David Marks  
7/12 Wilshire Ave Cronulla NSW 2230  
Tel: 0425 214 594  
david@marketlink.com.au

**STATE SIGNIFICANT DEVELOPMENT APPLICATION SSD - 8950984  
BURRENDONG WIND FARM – PROPOSED WIND FARM WITH UP TO 70  
WIND TURBINES AND ASSOCIATED INFRASTRUCTURE**

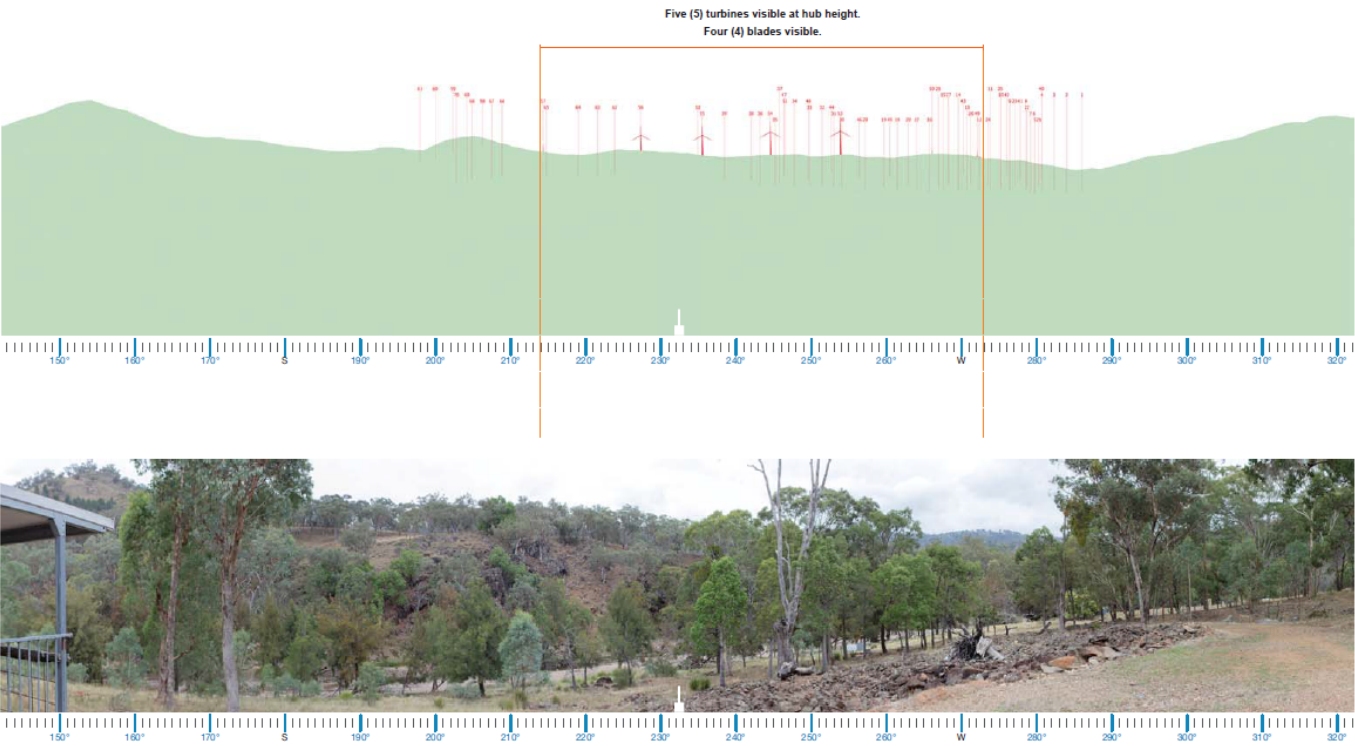
This is our mark up of missing non-residences from Worlds End area.

- The above map that Arc Energy did for the project does show other non-hosting residences so why eliminate non-hosting residences from Worlds End now for the submission?
- Based on the misrepresentation and omission of the non-associated dwellings this application must be refused.
- They say that the visual impact is negligible, very low or low. We have 400ha and of that 390ha have a front-line view of the WTG. We purchased our property to be away from infrastructure and for the vista and now we get wind turbines.
- The two maps below (A.8. MLA-01 Assessment) were supplied to us by Moirs. Why are these maps not included in this EIS? The modeling by Moirs clearly shows significant impact to our property.

Section of Figure 6-5. Highlighted area is the rough area of Worlds End

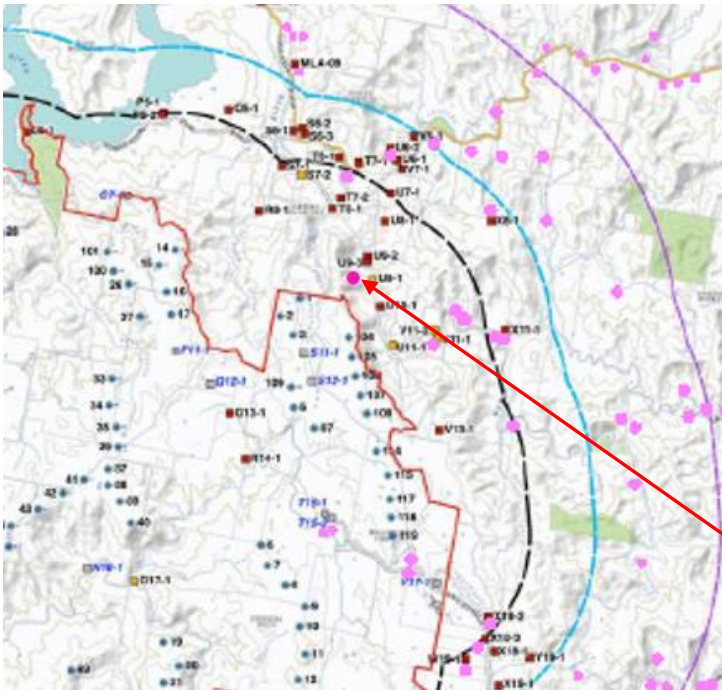
- Figure 6-5 Non-associated dwellings located within the Black and Blue Lines of Visual Magnitude. This map proves that they have no idea on what they are taking about as the seven identified residences in Worlds End are not in Worlds End but are in Yarrabin.

- So, now we are back to the fact that NO residences in Worlds End are recorded as being there.

- R8-1 T7-2 U8-1 S7-2 and U7-1 but our property U9-3 is not on the map. This incorrect exclusion needs to be corrected.

Fig 6-71. Dwellings next to WTG.

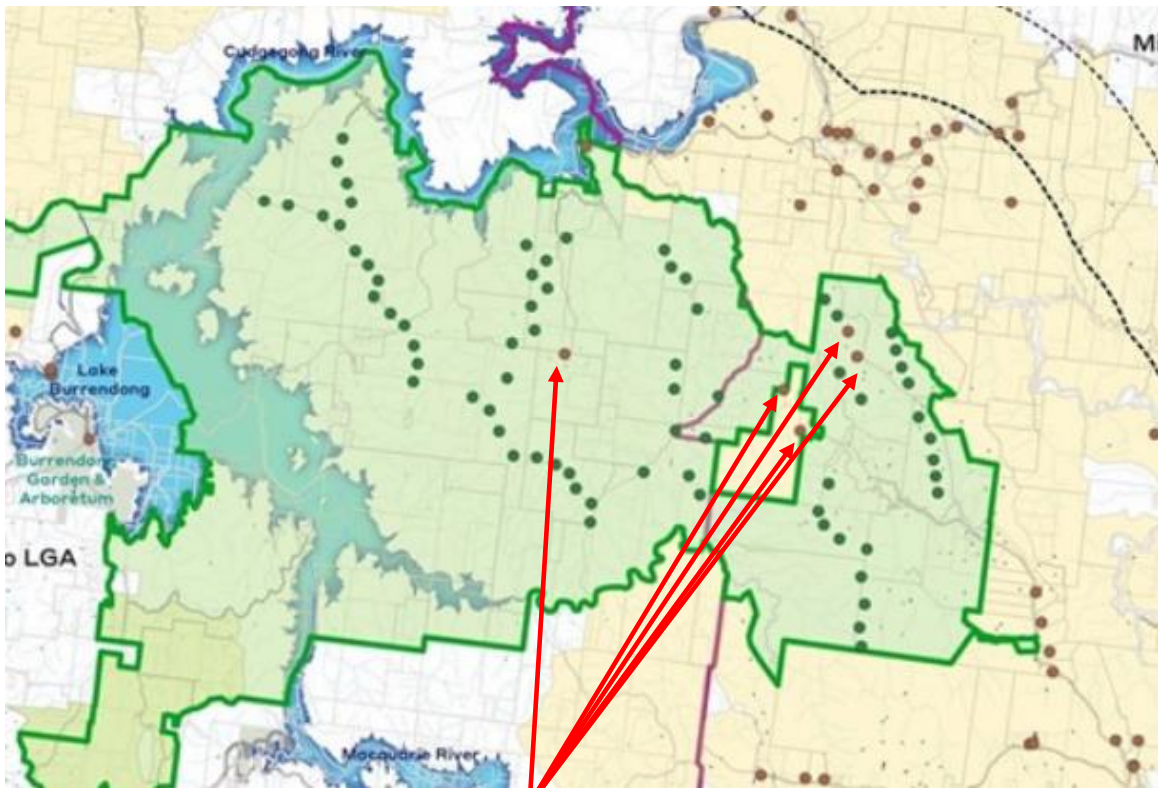
- According to figure 6.71 Worlds End residences and people do not exist. Also, by interpreting this figure, which has no scale in the map for measuring, there are five (5) dwellings (brown dot) within metres of the WTG. How can this happen? I thought there was a buffer zone from residences?

Fig 6-71 Some of the missing Residence

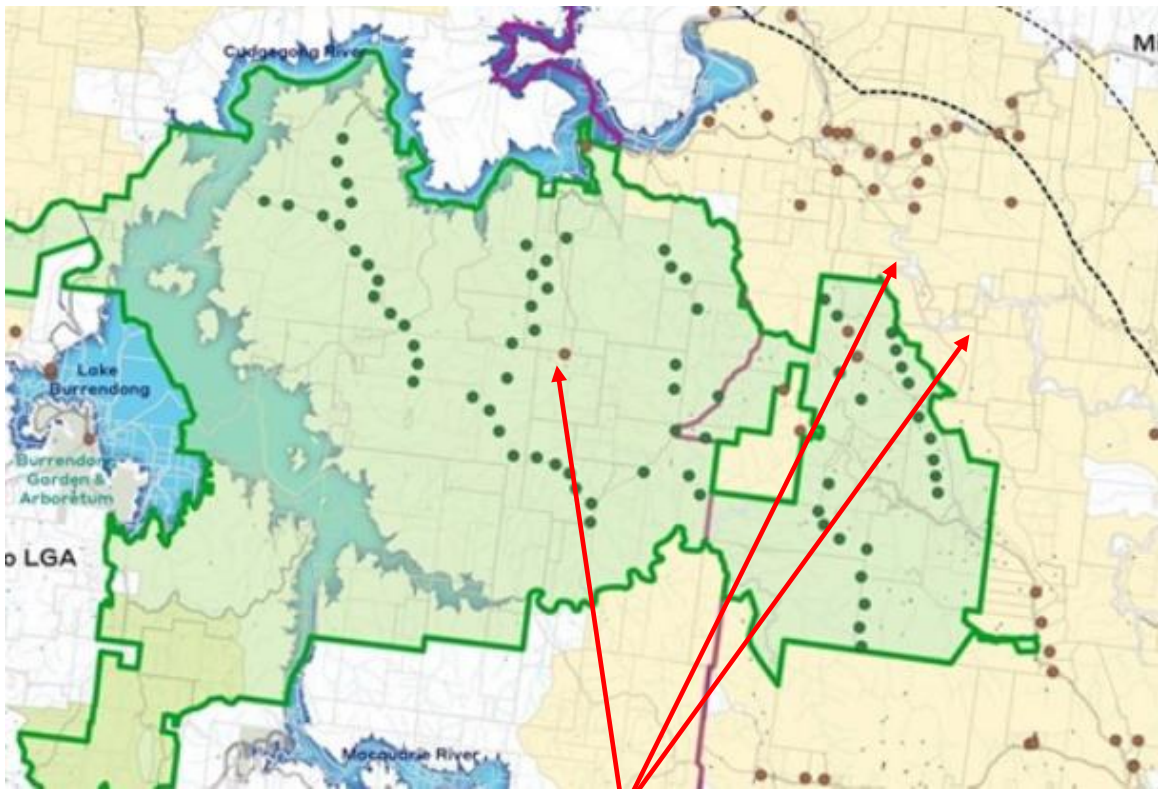
- Between the red arrows there is in excess of 20 residences missing from the data. In previous reports by both Epuron and then Ark Energy most of the residences were identified. Why are they missing here?

Figure 6-1 Visual magnitude analysis Scoping report Eco Logical page 70

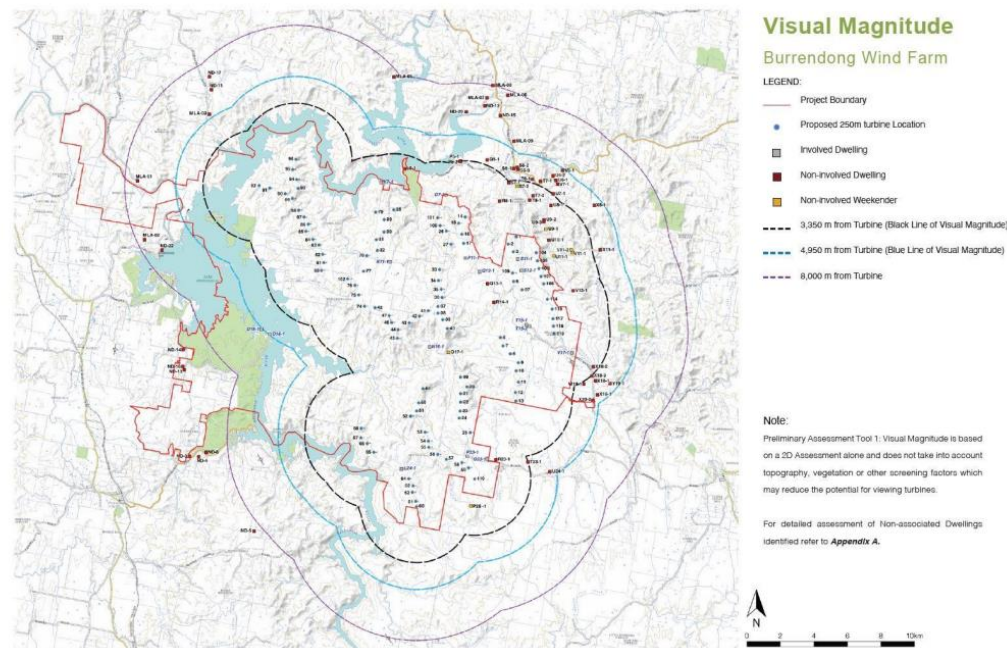
- The above map taken from the scoping report from Eco Logical shows many residences listed on this figure. Especially all of the residences in Worlds End. As per normal all of the maps from Eco Logical are hard to read so I have taken a section that shows residences in Worlds End that they appear to have removed on purpose.

Figure 6-1 Visual magnitude analysis Scoping report Eco Logical page 70 close up view.

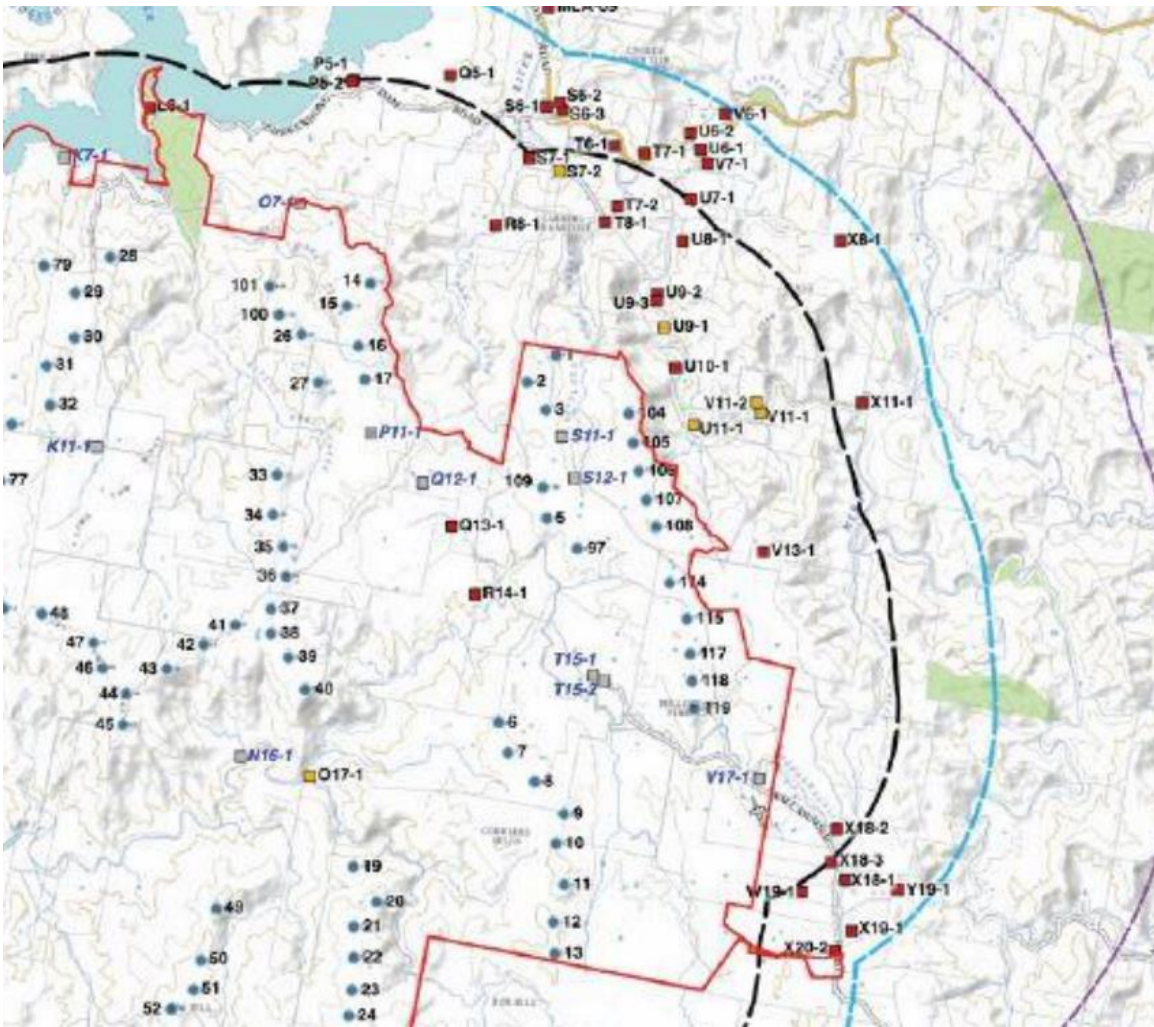
- As the numbers are blurry the following are some of the properties that have been intentionally left off from all components of this EIS report. This list is not the entire missed residences that were previously identified by Arc Energy and Eco Logical.
  - T7-2
  - U8-1
  - U9-2
  - U9-3
  - U9-1
  - V10-2
  - V11-2
  - V11-7
  - V11-1
  - V13-1
  - X11-1
- So, one must ask why has Arc Energy and Eco Logical made a misrepresentation to this magnitude in this EIS report?
